EXIDE POWER SYSTEMS DIVISION ESB INCORPORATED RALEIGH, N.C. 27604			GENERAL ELECTRIC DRY TYPE TRANSFORMER GEN. PURPOSE WITH INPUT BREAKER
DRW: R ALLEN 7-5-79 CR: W.A.P. 7-5-79 DATE: 7-5-79 SCALE: 1/2"=1'-0"	B 149 958 110

STONE & WEBSTER ENGINEERING CORPORATION
 NINE MILE POINT NUCLEAR STATION - UNIT 2
 NIAGARA MOHAWK POWER CORPORATION
 J. O. 12177

1 FUNCTIONAL TITLE (E1) (LIMIT TO 44 CHARACTERS & BLANKS) (37-80)
 TRANSFORMER-GENERAL PURPOSE POWER

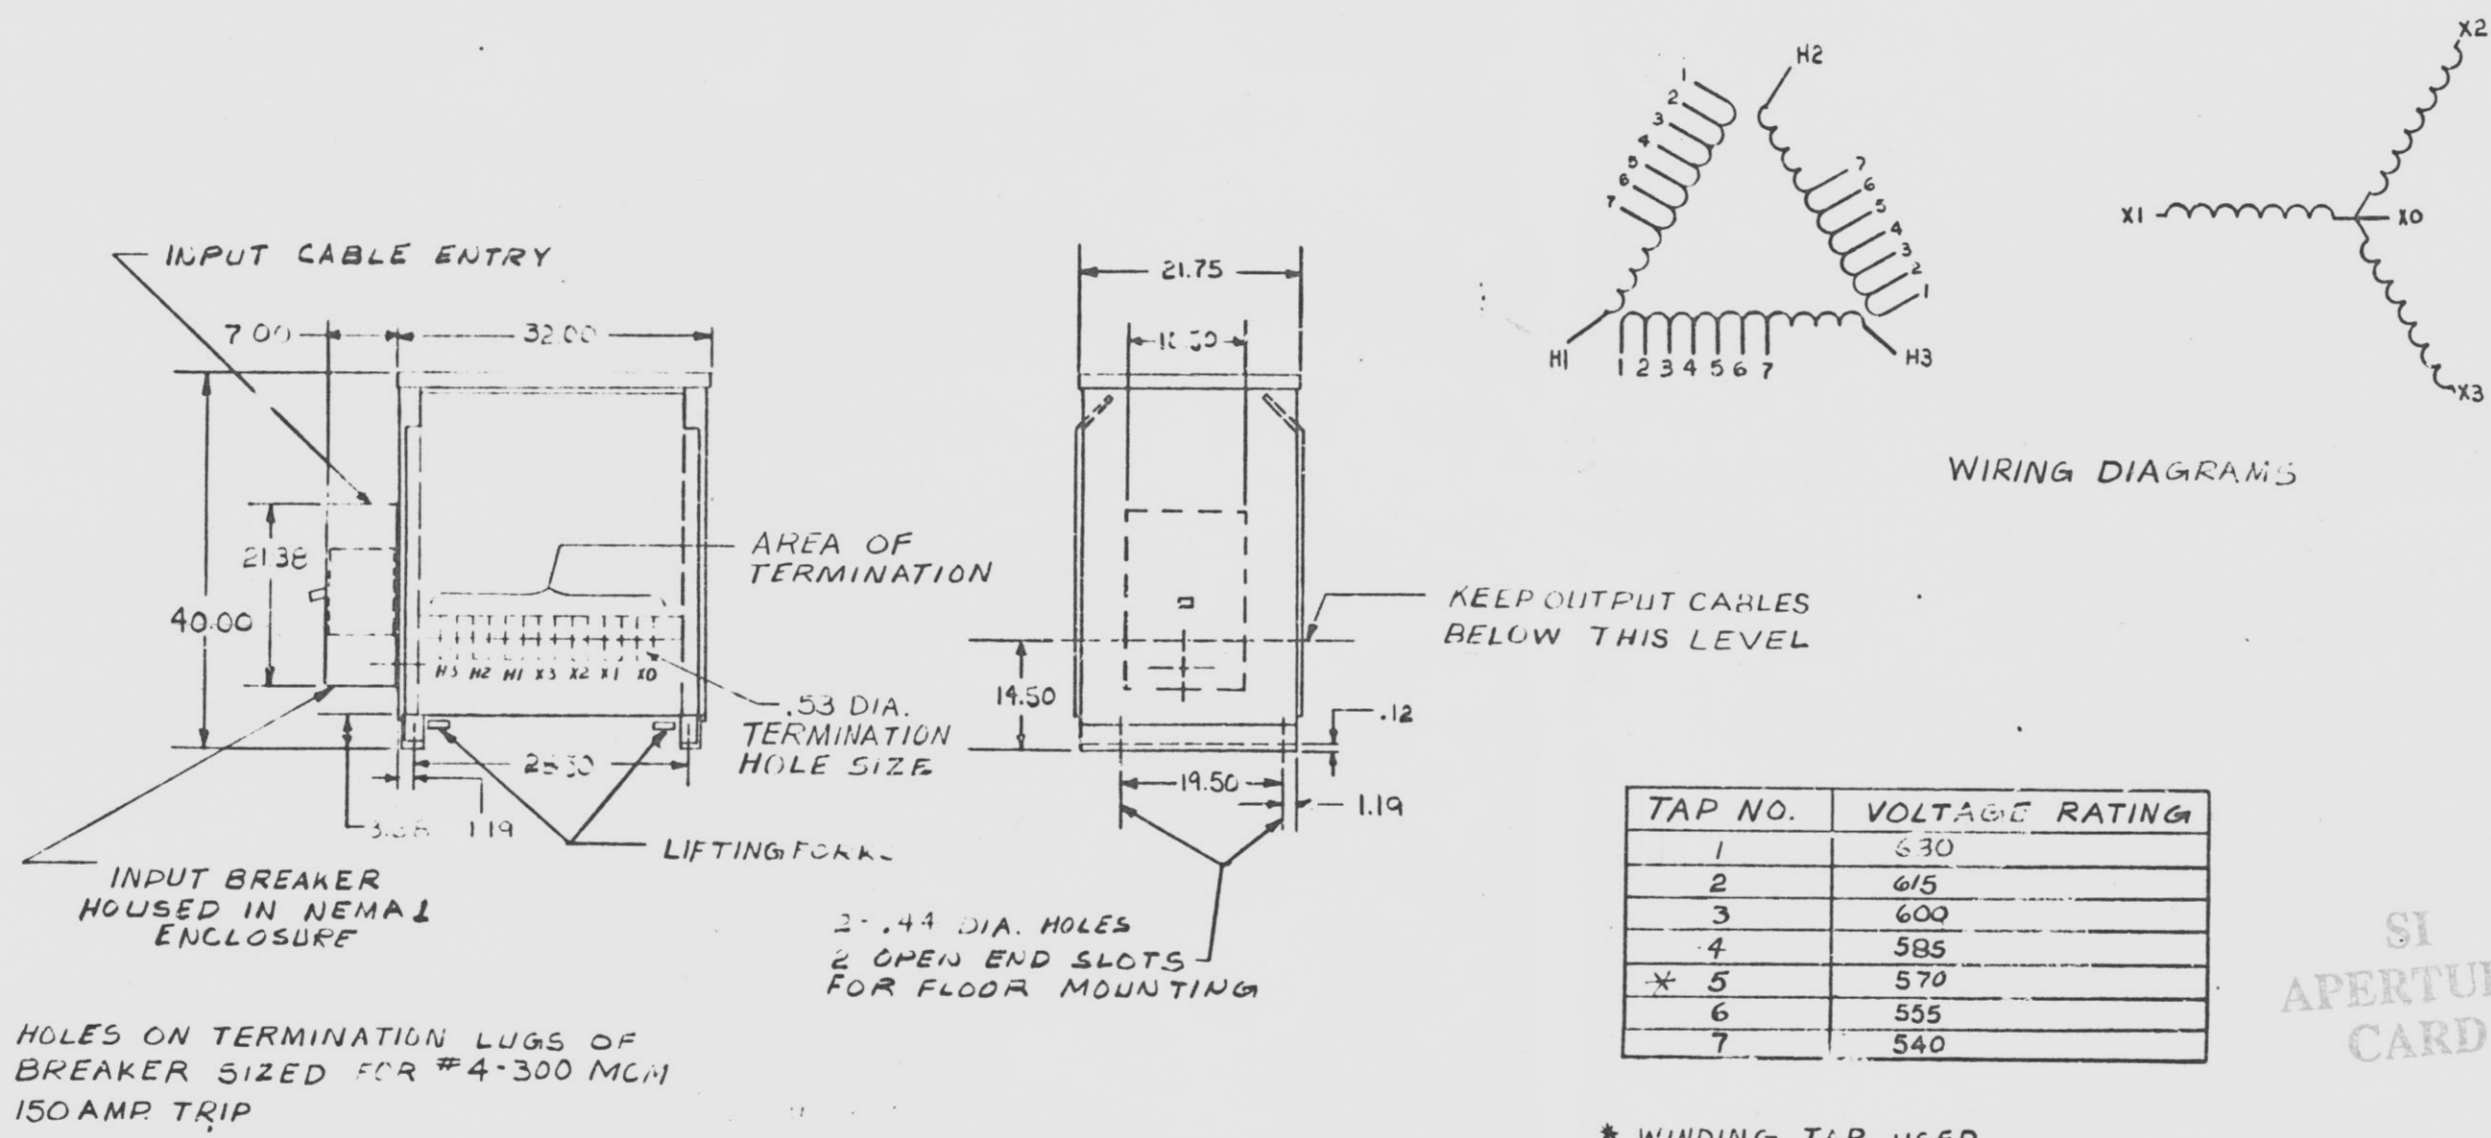
INSTRUCTIONS TO SUPPLIER (E2)

APPROVED AS DEFINED IN SPECIFICATION
 APPROVED AS REVISED
 RELEASED FOR FABRICATION
 RELEASED FOR MATERIAL PURCHASE

SUPPLIER TO RESUBMIT	Q	REVISED PRINTS
	N	REVISED MICROFILM
	T	APERTURE CARDS
	Y	
		FOR REVIEW
		FOR RECORD
		<input checked="" type="checkbox"/> NONE REQUIRED
